Craig Model 4353, 4354 Service Bulletin# 012578

SB# 012578
January 25, 1978

Lamp Ground P.C.B.

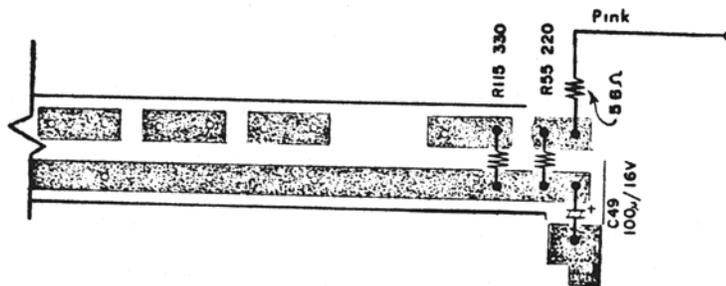
PROBLEM: 4353 or 4354 Scanning Lamps Intermittent, and skips channels, voltage to the lamps and switching transistors is too high

- SOLUTION:
- 1) Unhook the pink or pink and white wire going to R55 on the Lamp Ground P.C.B.
 - 2) Solder a 56 ohm $\frac{1}{2}$ watt resistor onto the P.C.B. in its place.
 - 3) Connect the loose wire to the other end of the resistor, cover with sleeving.
